April 30, 2025

RE: The Point South – Phase 5
Case Number: FSP-25-08
Response to 1st F9 Plat Phase 5 Review Comments
AWH20000

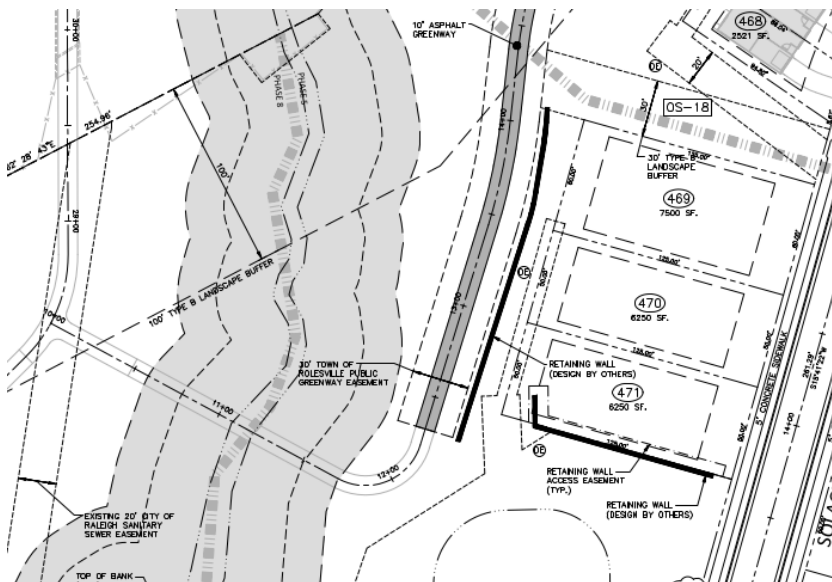
1. Please revise to show all of Greenway easement in Phase 5, include the section of bridge/boardwalk that goes over the creek. Excerpt on Left from PR 20-01 / on Right from FSP-25-08.

McAdams Response: See snippet below from approved CD's for CD package 2. This portion of the greenway easement matches the approved CD's for this package. The remainder of the easement will be recorded in future phases.
